Midway City Council 7 December 2021 Regular Meeting

Daybell Garage Mixed-Use Development / Conditional Use Permit

CITY COUNCIL MEETING STAFF REPORT

DATE OF MEETING:	December 7, 2021
NAME OF PROJECT:	Daybell Garage Mixed Use Project – Restaurant and Residential Unit
NAME OF APPLICANT:	Wayne Gordon, agent for Bill Nibley
AGENDA ITEM:	Conditional Use Permit
LOCATION OF ITEM:	289 South Center Street
ZONING DESIGNATION:	C-2

SITE PLAN KEYE	<u>ED NOTES</u>		
		(- 8' MIN./30' MAX. AL SETBACK FROM (E) RESIDENTIAL L	ISE	
		PHALT PAVEMENT	J2E	. 5 8
	4. (E) GRAVEL PAR 5. (E) SIDEWALK	rk strip

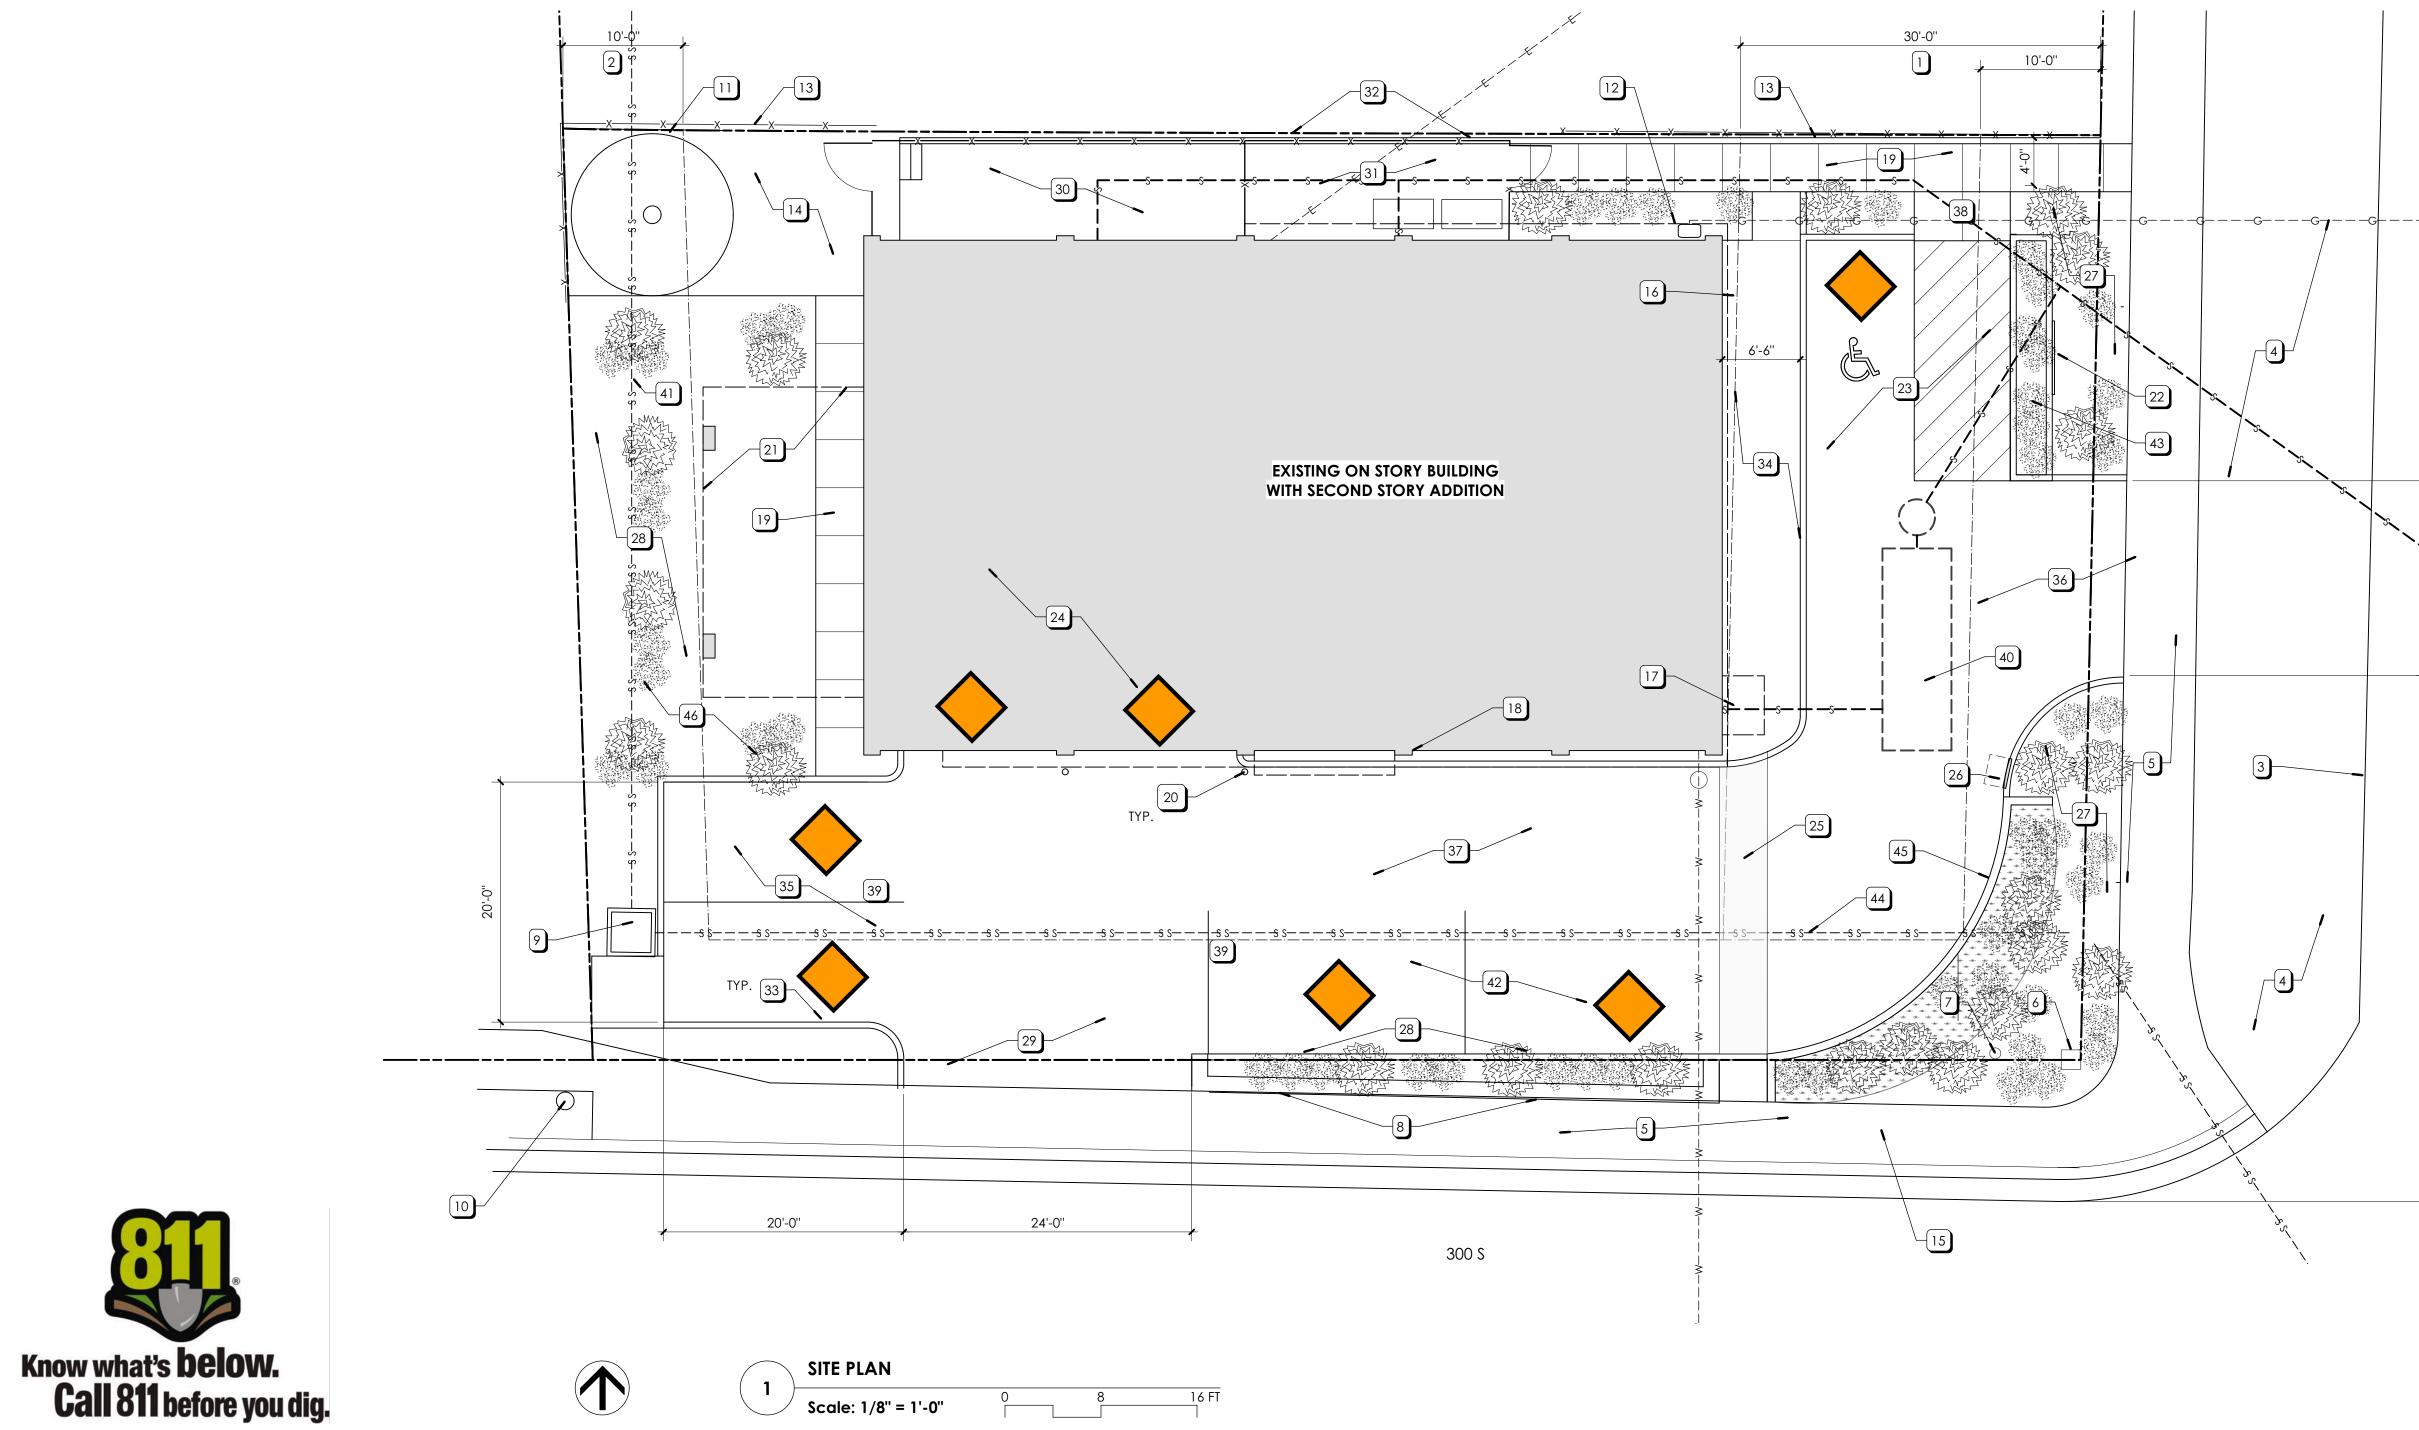
Clearview - The applicant will need to ensure that anything (signage, trees, landscaping) placed within the 45' clear view area along the intersection of 300 South and Center Street is appropriately sized and does not create a safety hazard.

be located along the north side of the building behind a fence. Care should be taken to ensure that the trash containers are kept within the fenced area. The property adjacent to where they would be located is zoned commercial and is mostly vacant. The owner will be required to pull the containers to the designated public street for trash pickup.

The applicants plans also depict areas where snow can be stored so that it is not displaced into the city right-of way.

Setbacks – All structure setbacks will remain the same except for the setback to the west property line. The applicant is proposing a balcony for the residential unit. The C-2 Zone requires a 10' residential setback when part of a mixed-use development, which it appears to meet.

Parking/Vehicular Circulation/Drive-thru Window – Because the applicant is designing around an existing building on a relatively small parcel, a major obstacle encountered has been accommodating the various uses along with the vehicular parking and circulation requirements. The applicant would like to use a drive-thru window, but there currently is not adequate space to accommodate it along with the required parking and vehicular pass-through lane. The applicant is working with a neighboring property owner to see if they are able to lease property to help satisfy their required off-street parking. With city council approval, a business can relocate some required parking on a neighboring property. Because those arrangements are not in place, the applicant is proposing a phased approach to realizing the drive-thru window. *The current proposal would use the drive aisle as a pass-through for vehicles* and parallel parking. If the applicant can negotiate a lease allowing them to relocate some of their required parking to a neighboring property, and that arrangement is approved by the city council, they would then install the drivethru window and move the pass-through lane to the south where the two parallel parking spots are. Staff is supportive of them installing a normal window in the spot where a future drive-thru window would be located, but we would recommend that no drive-thru window is installed until an off-site parking agreement is in place and the two parallel parking stalls are relocated.

Currently, the site plan shows two stalls in the garage and five off-street parking stalls, which satisfies their obligation to provide seven off-street parking stalls.

- 1. Must have approval from UDOT for existing access before proceeding to the City Council.
- 2. Must obtain an updated will-serve letter from Midway Irrigation Company before building permit approval.
- 3. No building permit may be issued unless final written approval has been provided by the City Engineer.
- 4. Must obtain a final recommendation of approval from the Vision Architectural Committee before consideration by the City Council.
